Würth Elektronik eiSos GmbH &amp; Co. KG

## Product / Process Change Notification (PCN)

<b>PCN #:</b> PCN_IndCMBHC_20201228 <b>Affected Series:</b> WE-CMBHC-Series 744822xxx  <b>PCN Date:</b> September 28, 2020 <b>Effective Date:</b> December 28, 2020	<b>Change Category:</b> <input type="checkbox"/> Equipment / Location <input checked="" type="checkbox"/> General Data <input checked="" type="checkbox"/> Material <input checked="" type="checkbox"/> Process <input type="checkbox"/> Product Design <input type="checkbox"/> Shipping / Packaging <input type="checkbox"/> Supplier <input type="checkbox"/> Software
<b>Contact:</b> Product Management <b>Phone:</b> +49 (0) 7942 - 945 5001 <b>Fax:</b> +49 (0) 7942 - 945 5179 <b>E-Mail:</b> pcn.eisos@we-online.com	<b>Data Sheet Change:</b> <input checked="" type="checkbox"/> Yes <input type="checkbox"/> No  <b>Attachment:</b> <input type="checkbox"/> Yes <input checked="" type="checkbox"/> No

Spacer drawing for CMB Series 744821xxx

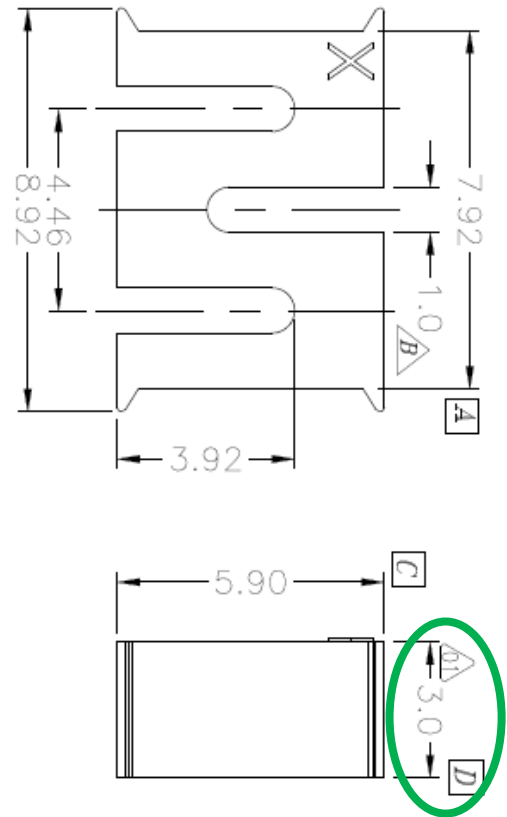
To assure assembling processability, Würth Elektronik will change the spacer thickness from currently 2 mm to 3 mm. For detailed information, refer to drawings on next page. As example the spacer drawing for CMB Series 744821xxx.

Picture 1

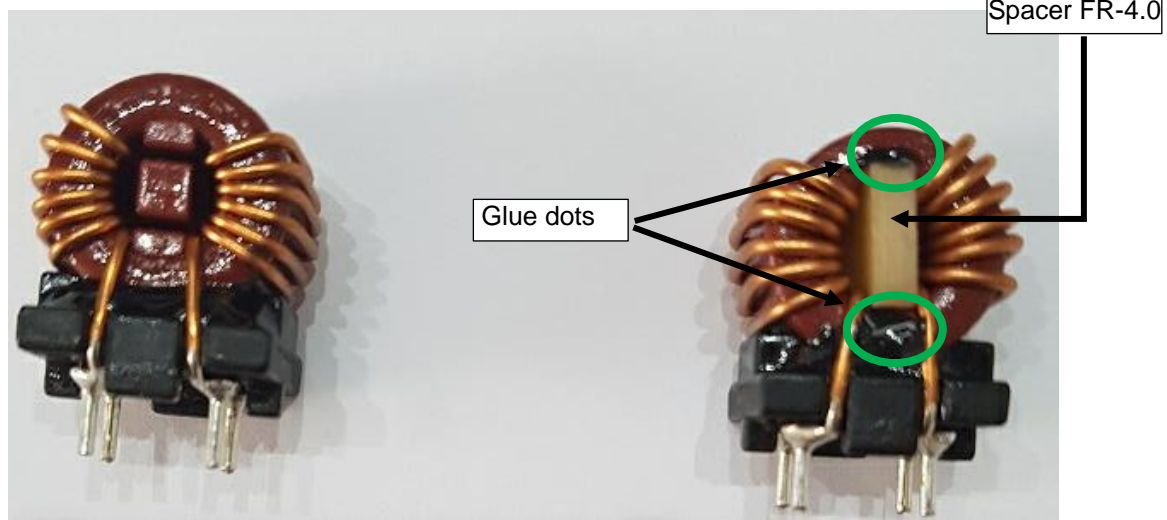
For some articles it was not possible to implement this change as the winding distance between both windings is insufficient. In this case we will implement new spacer based on FR4- Material, with material thickness 2,0 mm or 2,5 mm and UL-File number E123995. We also will add 4 glue dots on the spacer to achieve the 3 mm minimal creepage distance between windings. Affected articles are listed on **table 1** and shown under **picture 1**.
